CMB Meeting Minutes #143

REFERENCE Project No. M544.1, Contract No. 149 Task 1-8.02

SUBJECT: Configuration Management Board Meeting # 143 – Rev. No. 0

Project No. M544.1, Contract No. CS-149
Program/Construction Management
Configuration Management Board (CMB) Meeting No. 143 Rev1
October 09, 2013
3:00pm – 5:00pm
 Central Subway Project Office
 821 Howard St. 2nd Floor
 Main Conference Room

SHEET
EL-02

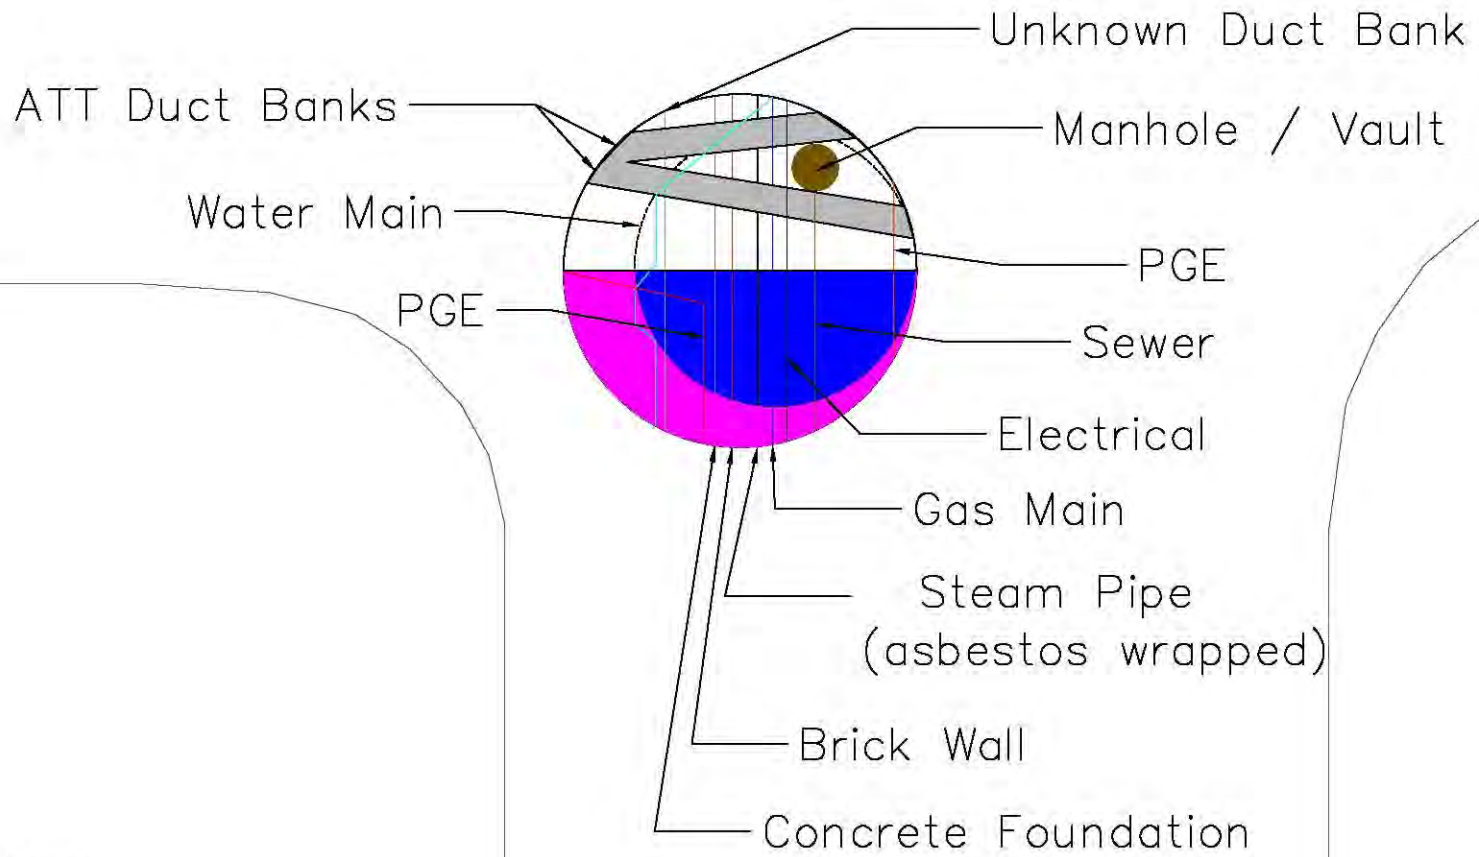
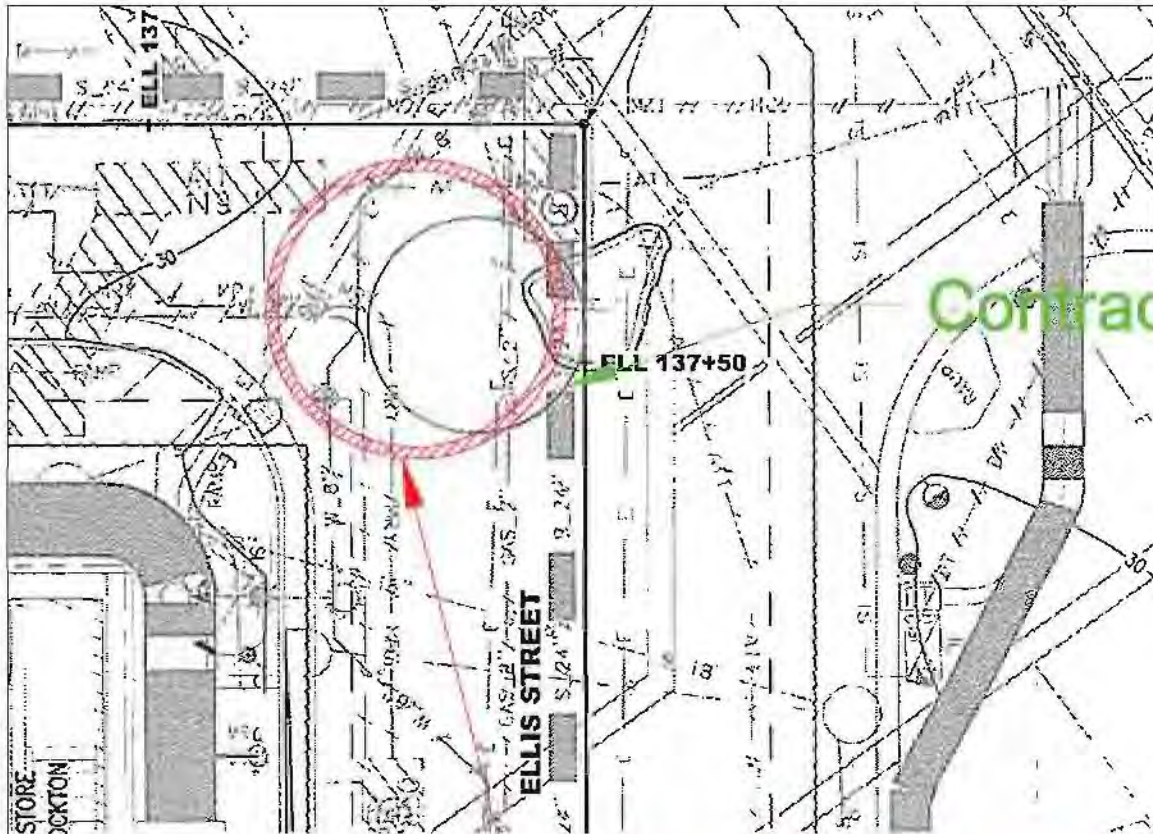
Facts: The Contractor discovered utilities at the Ellis shaft location that were not indicated on the utility demolition and utility composite drawings included in the contract drawings. The Contractor notified SFMTA of the utility conflicts on August 2nd, 2012 in Letter No.05 indicating that they would remove the utilities prior to submission of a COR. The Contractor has completed the removal of utilities at the Ellis shaft location. The Contractor did not submit a request for time extension.

Justification: The RE finds no Merit for removal of utilities shown on the Existing Utility Composite reference drawing UE-126 to cross the Ellis Shaft construction limits. This includes a sewer vault as well as low voltage electrical, sewer and gas utilities. The reference drawings were part of the contract documents made available to Bidders prior to the deadline for submitting bids. Additionally, no Merit shall be given for potholing as verifying the location of existing utilities is incidental to the work.

The RE finds Merit for removal of utilities not shown or indicated on the Existing Utility Composite reference drawing UE-126 to be outside the Ellis Shaft construction limits. This includes æ8" water main, an unknown duct bank, concrete foundation and brick wall, steam pipe and sewer manhole.

- 1. PHASE 1 DEMO = SOLID HATCH AREA (west 1/2)
- 2. PHASE 2 DEMO = NON-HATCH AREA (east 1/2)

**Modified Shaft Location/Diameter
From Submittal 31 43 14-002
(STA 136+83.802 OFF 94.152R, 10" wall)**

\\sv6nos003\m544.1\FinalDesign\DRAWINGS\CSI155-2\1253\SHEET FILES\03_STRUCTURAL\03_STRUCTURAL\12530303ST729.dwg
 bdauid Thu Feb 23, 2012 - 2:08 pm ST-729 ROOF FRAMING SCHEDULE AND DETAILS

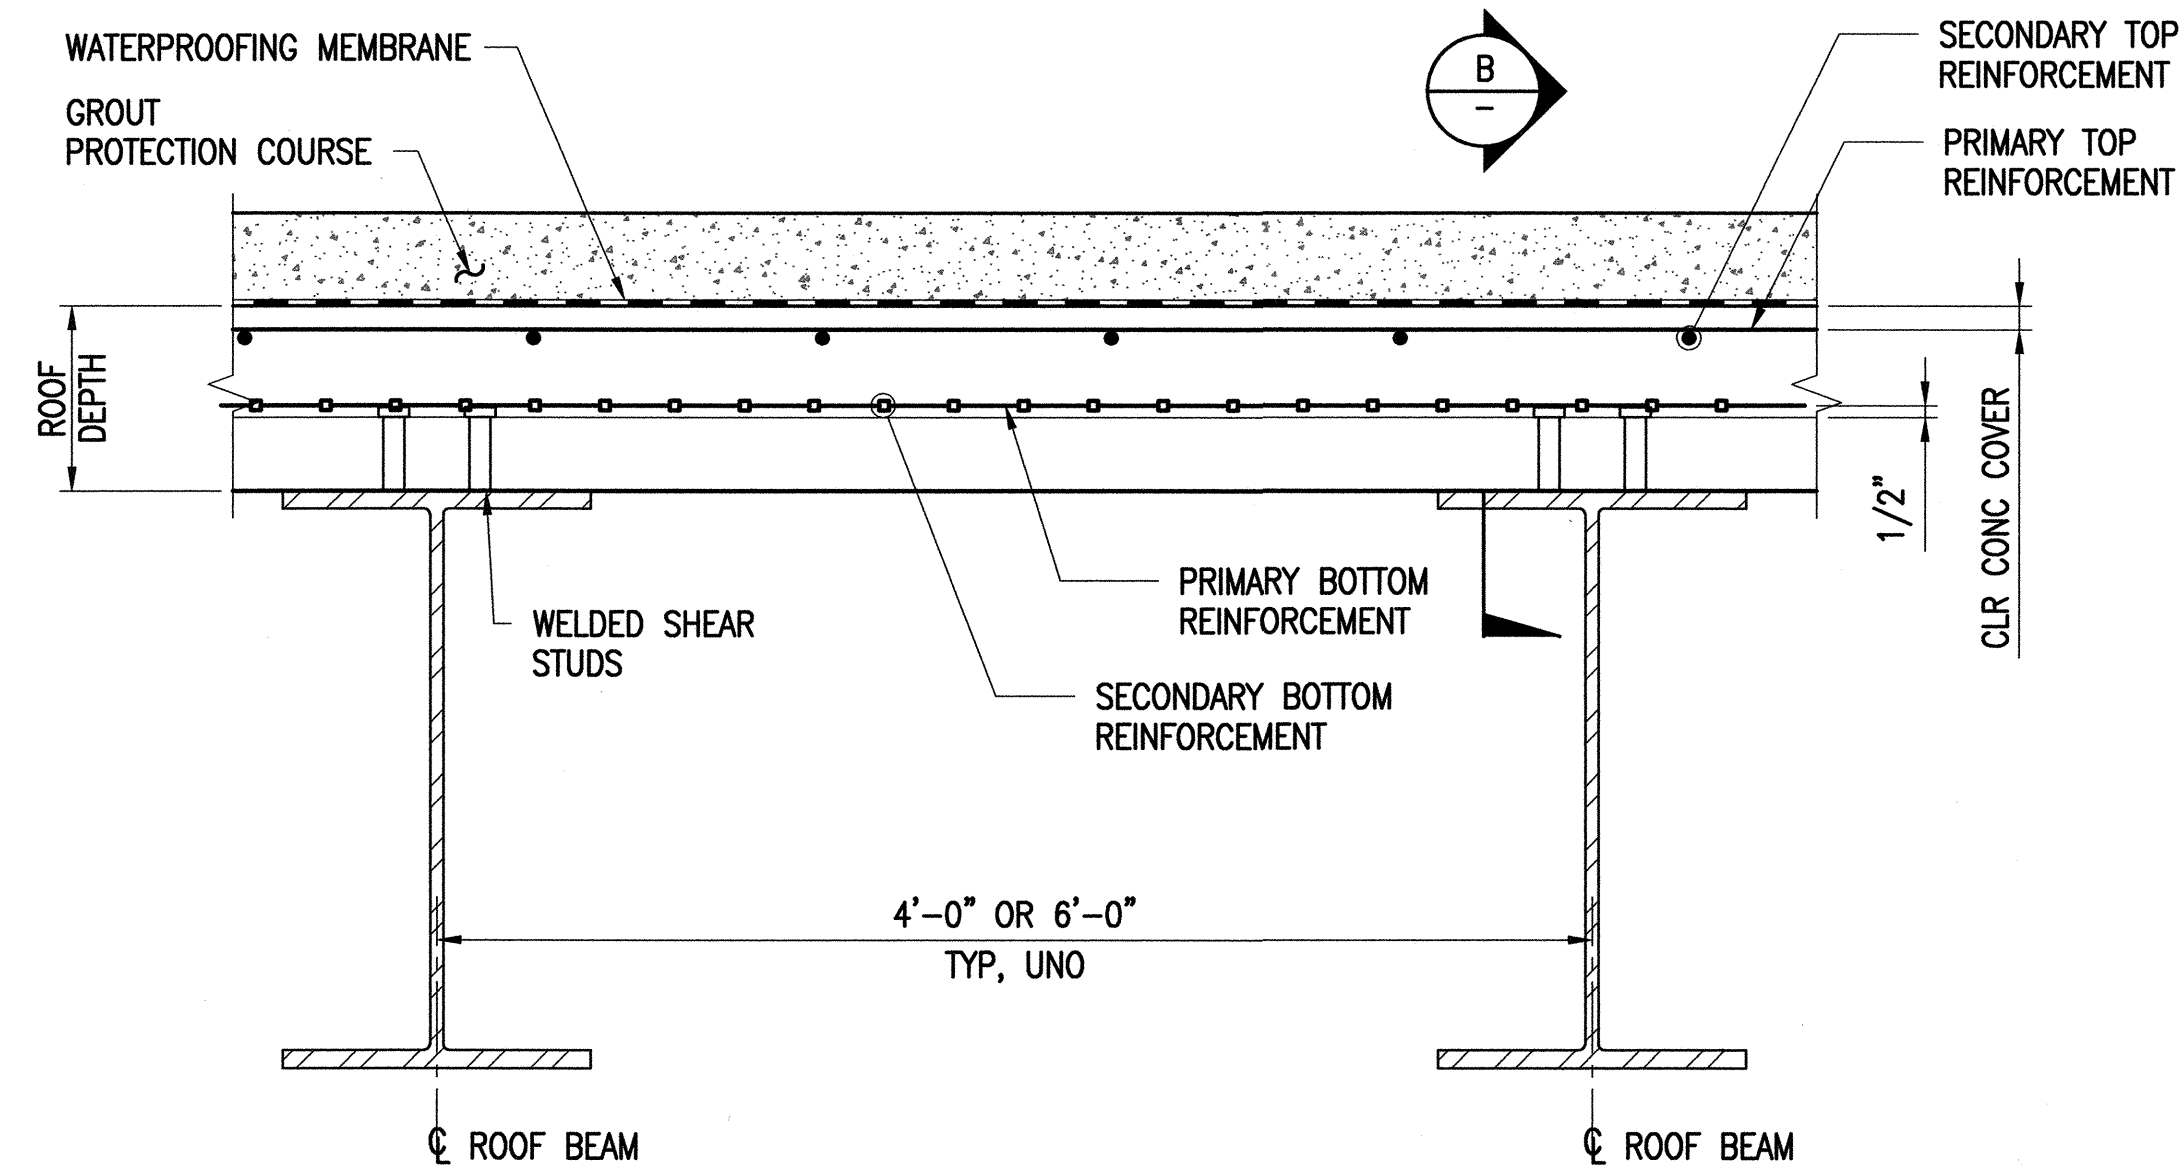
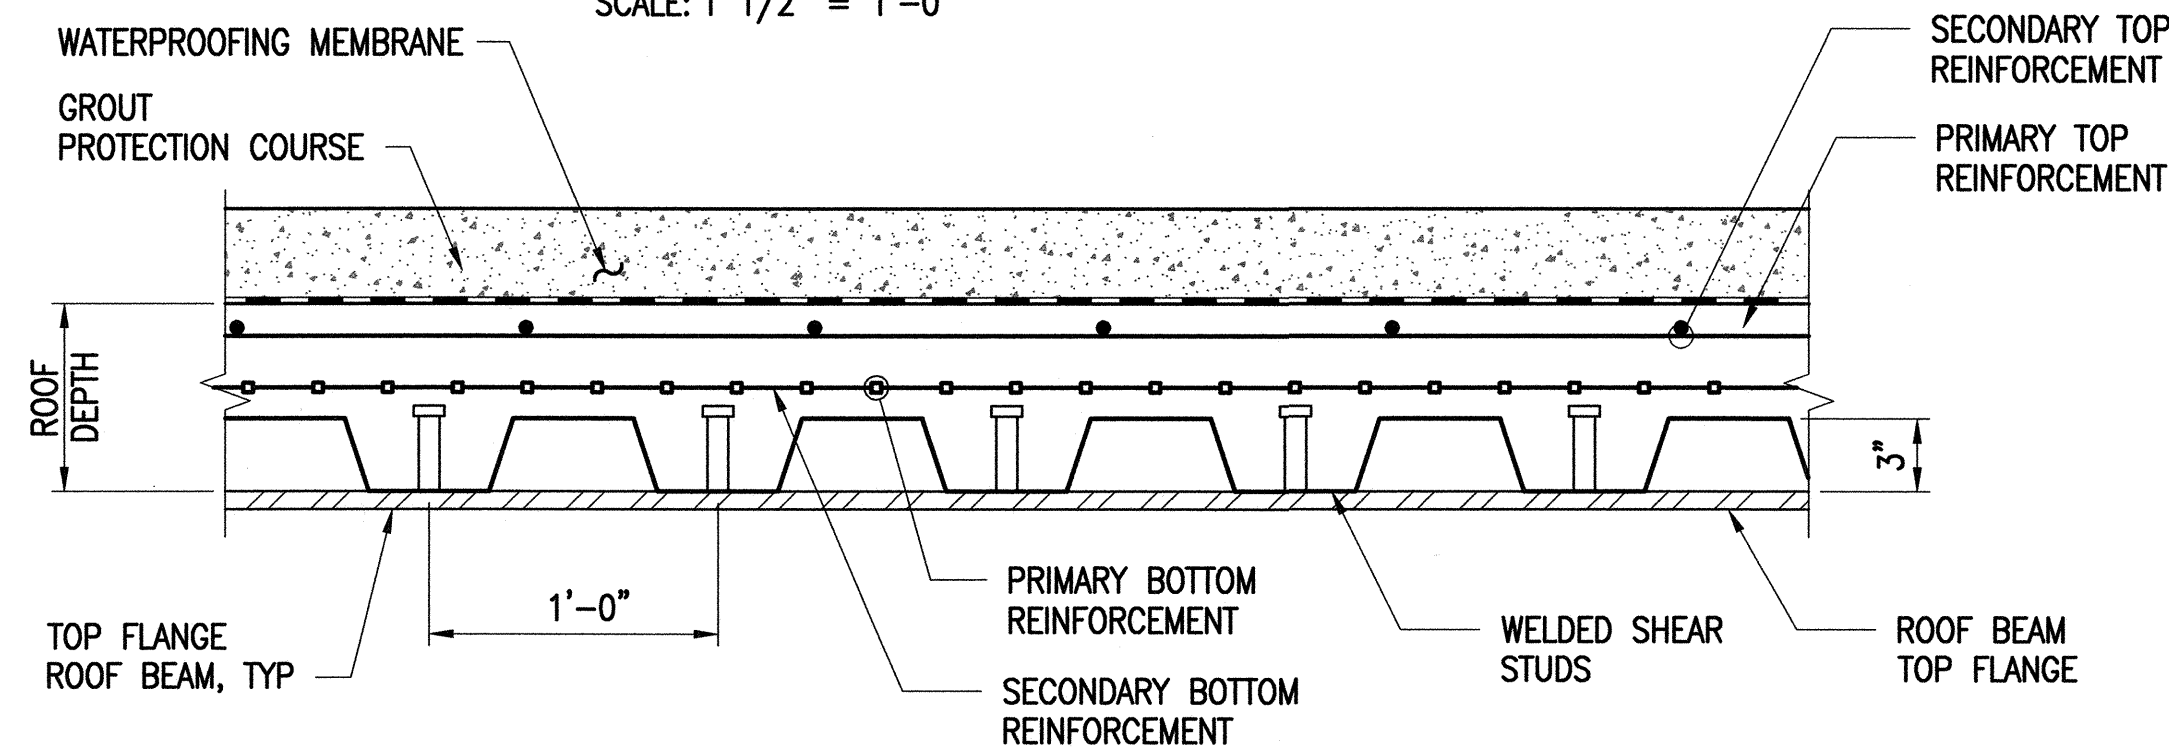
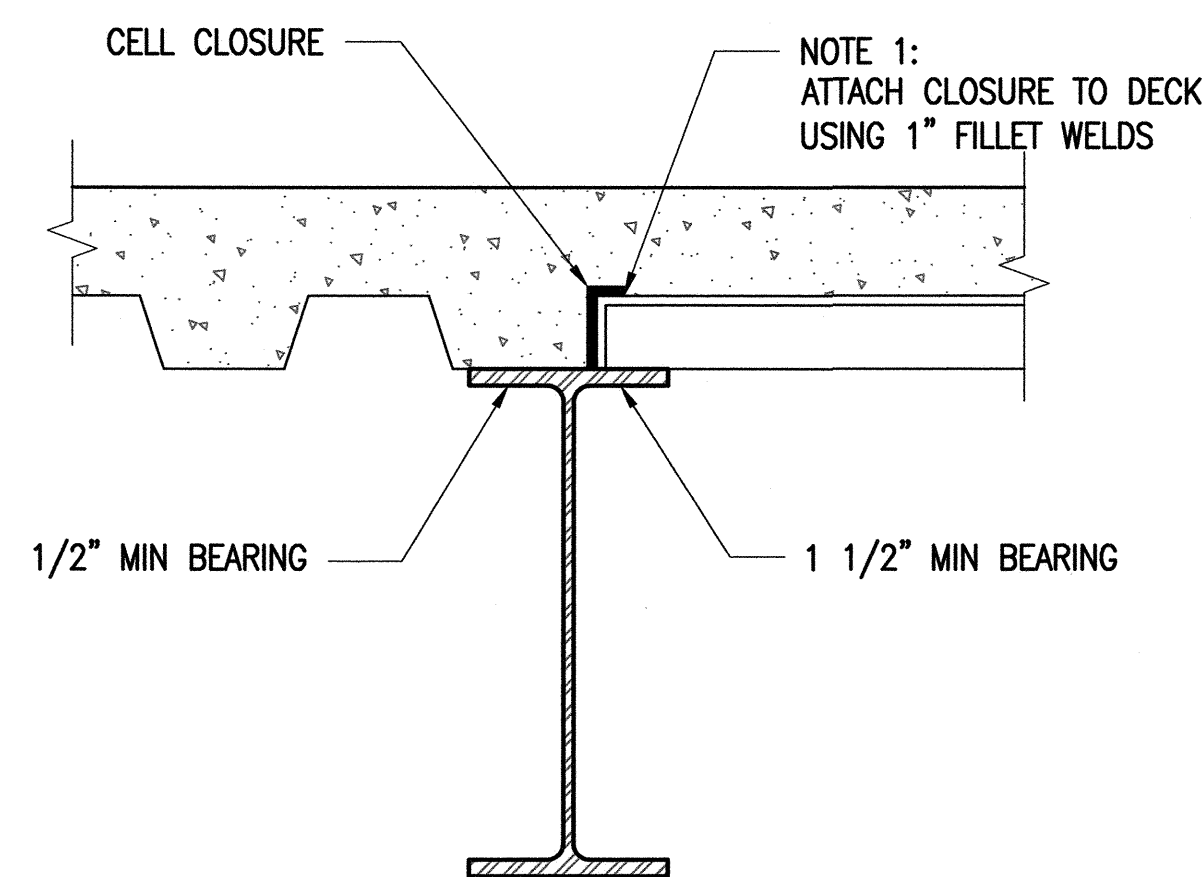
Sheet ST-729 shows 7/8" dia. x 3 1/2" welded shear studs. Please reconcile this with Section I3.2c.(1)(b) of the Steel Construction Manual which states "the concrete slab shall be connected to the steel beam with welded stud shear connectors 3/4 in. or less in diameter...stud shear connectors, after installation, shall extend not less than 1 1/2 in. above the top of the steel deck...".

Need to achieve the proper extension above the top of the steel deck. The beams capacities are adequate to withstand the net additional concrete dead load.
